Preliminary Tree Visual Impact Assessment - Keresforth Road in Dodworth

Please find enclosed my comments regarding the potential tree visual implications of the proposal concerning the visual effects for receptors of the proposed scheme. The following is a summary of the visual effects of the proposed tree removals and tree works.

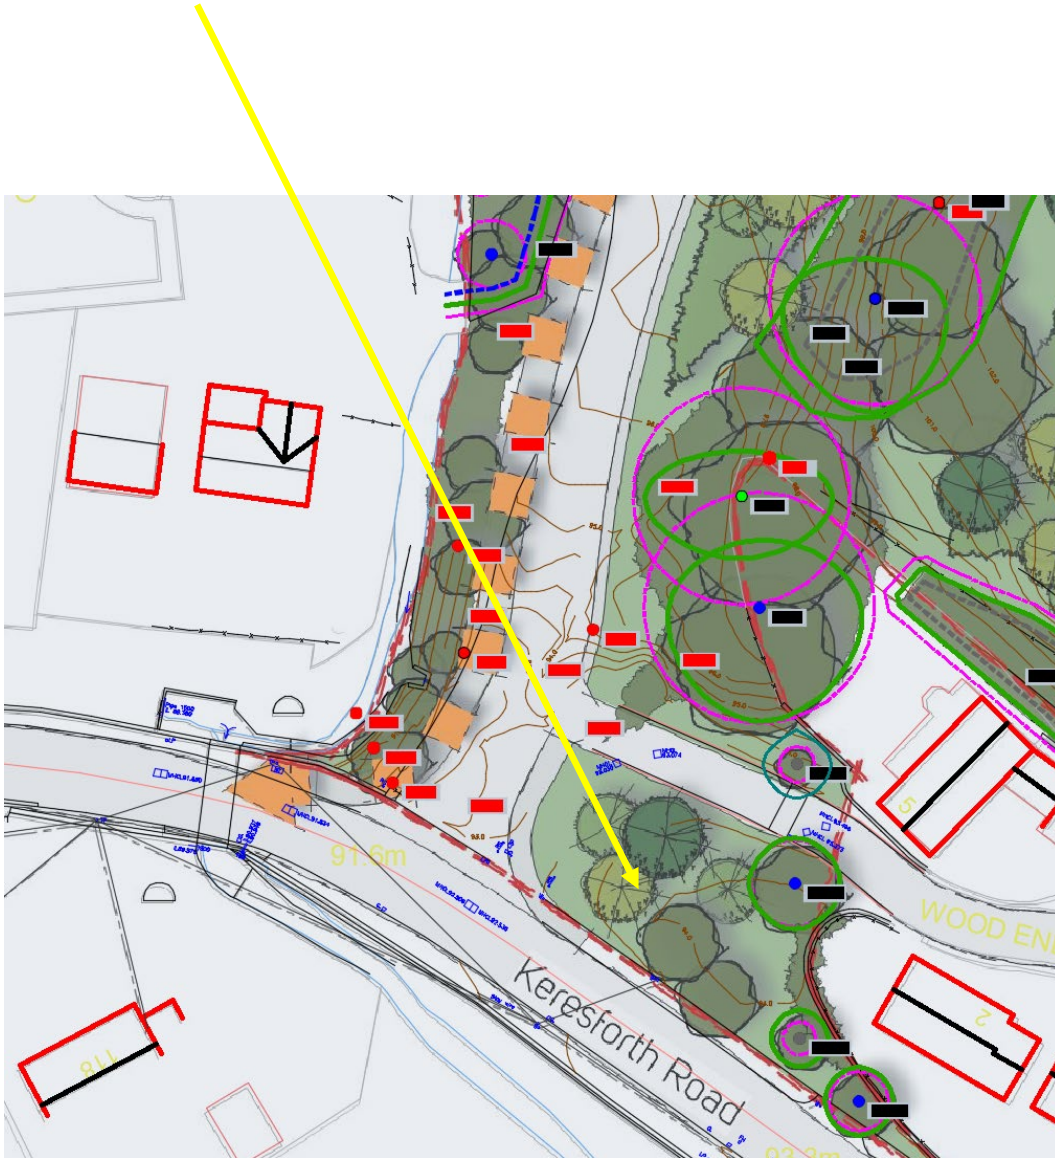
The proposal (shown below) requires the removal of the majority of trees bordering Keresforth Road. The trees to be removed are highlighted in red, copied from the arboricultural impact assessment BA11799.

The area of the study is centred around the access point marked with the orange arrow and orange dashed circle.

Site boundary and Study area with removed trees are denoted by red dots and red number boxes, the line of the proposed access is shown by an orange dashed line for more clarity.

Looking at the site entrance from the east

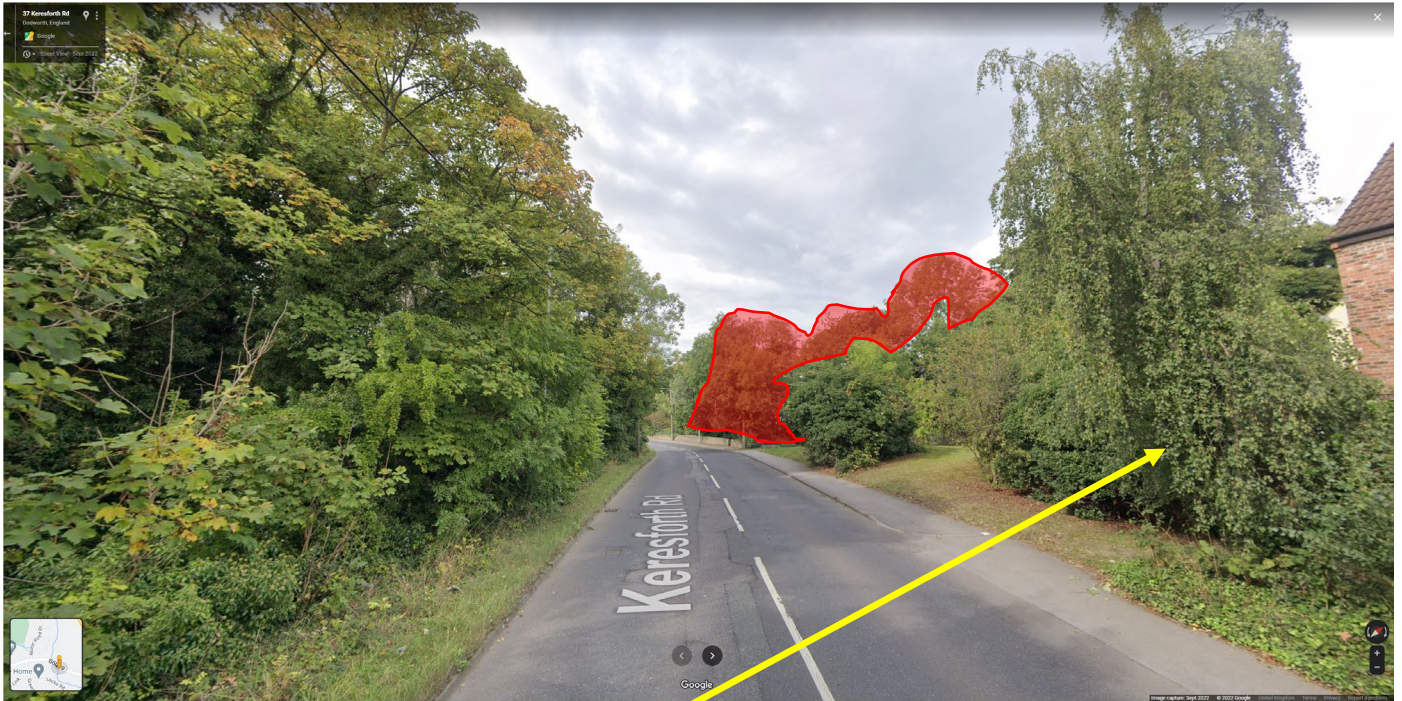
In the near view is the Silver Birch T27, with just beyond the retained shrub group. In the far distance are the higher canopies behind T27. The red shaded area shows the larger retained trees presumed to be T6 or T7, the trees and canopies in front of these canopies being removed.

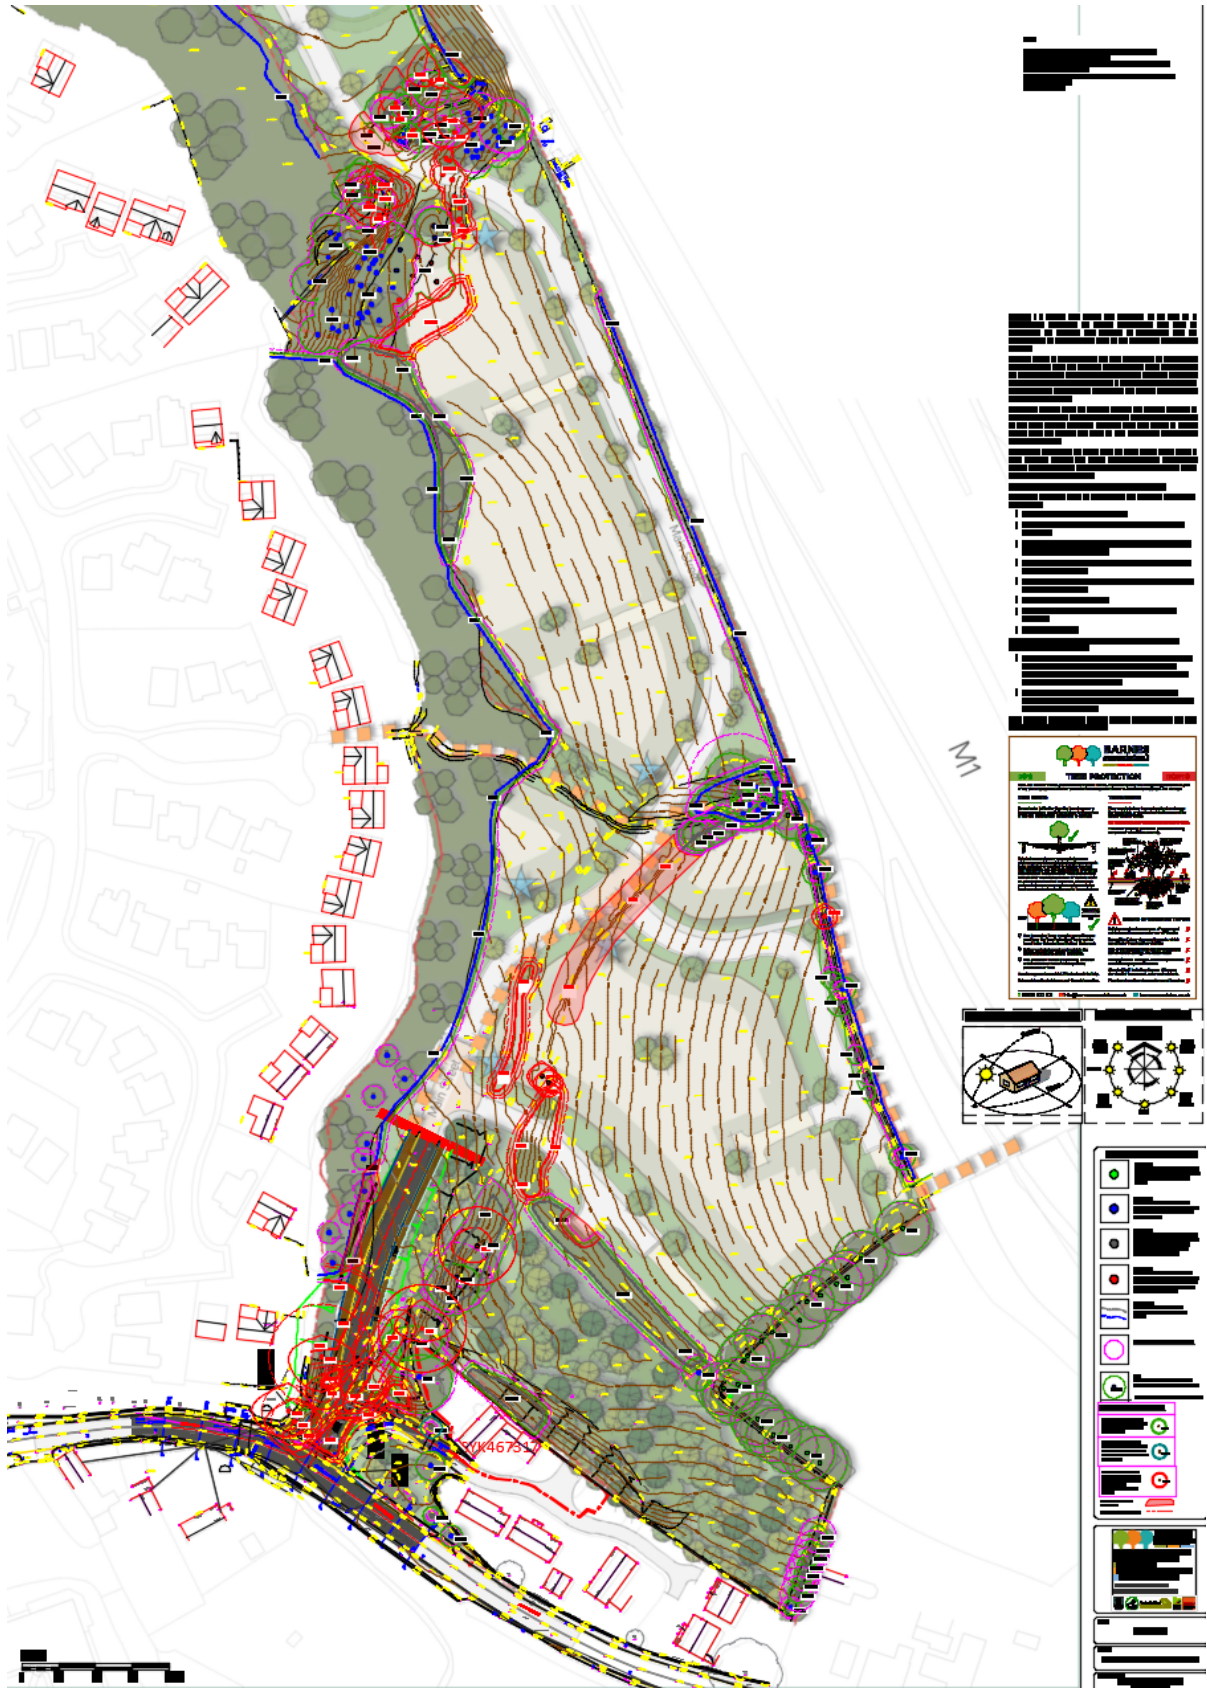
Tree Mitigation - The arboricultural impact plan BA11799AIA_A extract is shown below
This shows the following trees losses and their details are provided in appendix A.

The plan below shows additional tree planting to the front of the site, increasing the extent of planting shown on the original masterplan which will help improve screening. This is suggested additional planting as shown below, to represent large growing stock and trees species.

The tree species should be larger canopy trees such as Large-Leaved Lime, Oak, for example.

This additional planting provides large, canopied trees to help mitigate for the losses in the area close to the proposed entrance and is proposed to help mitigate the required area tree removals, the tree planting numbers to be agreed through reserved matters.

Looking north, north east into the site.

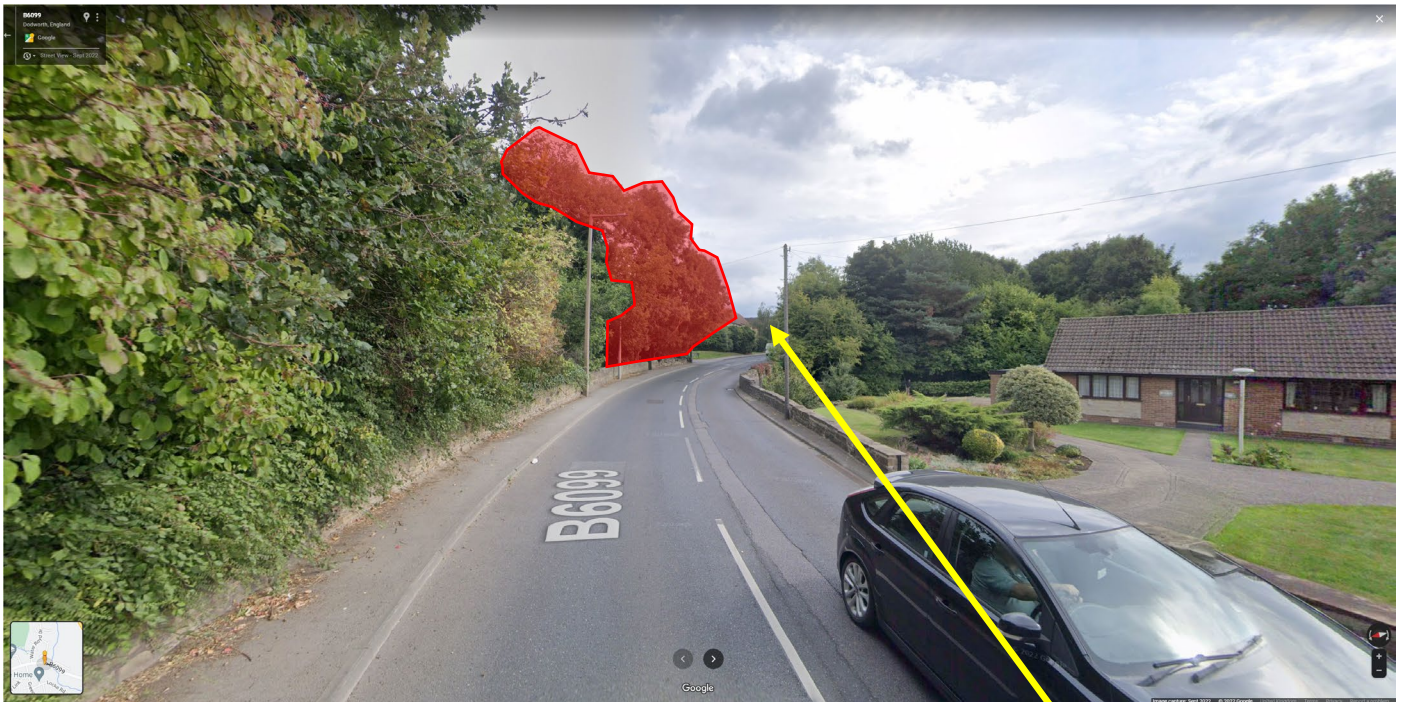
The resultant effect after additional tree planting to the west of the site, the entrance area, shows this area can be framed and screened by trees.

Looking at the site from the west.

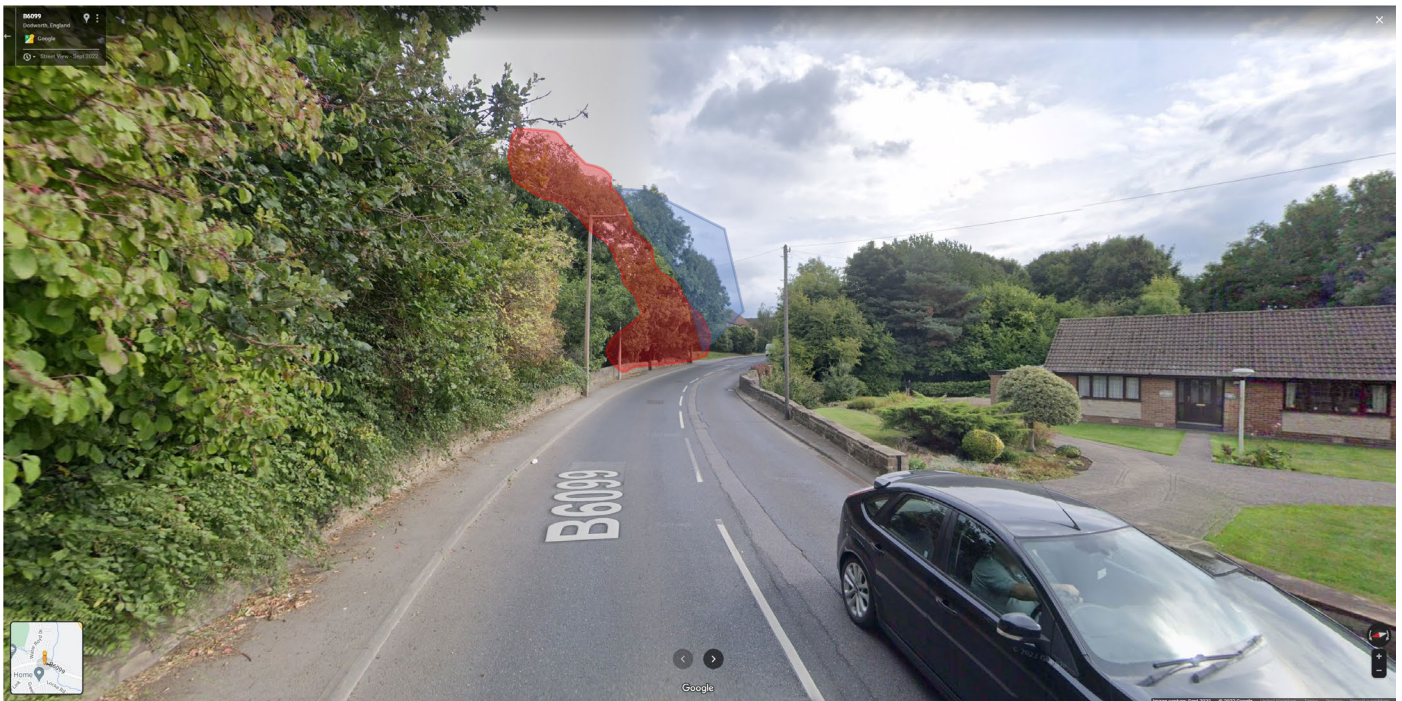
In the far distance are retained shrub groups and glimpses of the retained Silver Birch tree number T27 detailed by the yellow arrow.

Additional planting would be in view to the east of the site reducing the effect of lost vegetation to the west.

Looking at the site from the east.

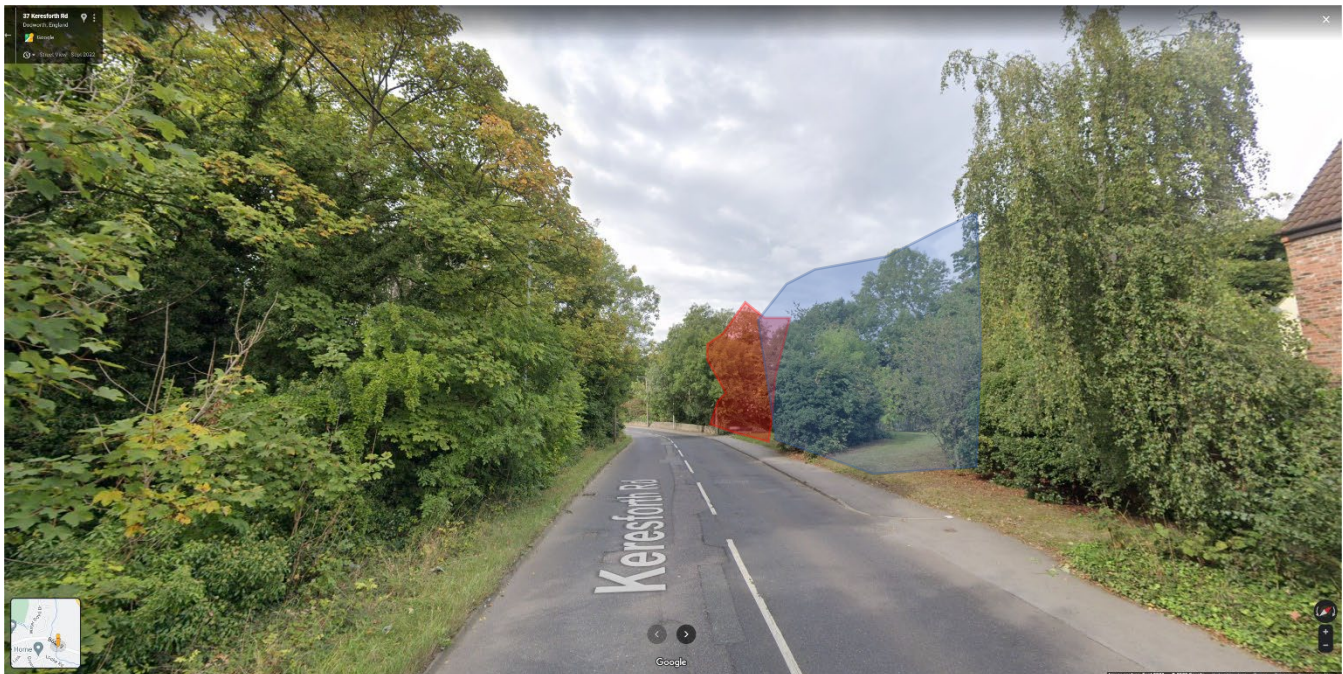
In the near view is the Silver Birch T27, with just beyond the retained shrub group. In the far distance are the higher canopies behind T27 shows the larger retained trees presumed to be T6 or T7, the trees and canopies in front of these canopies being removed.

The near view is enhanced with the additional new tree planting as the open grass area is reduced from this viewpoint and is replaced with new trees. This would distract the receptor from the loss of vegetation in the far distance this being the western side of the entrance. Whilst travelling passed the entrance, receptors would have further views of substantial new tree planting along the entrance area, with additional tree canopies in the medium term across the whole site.
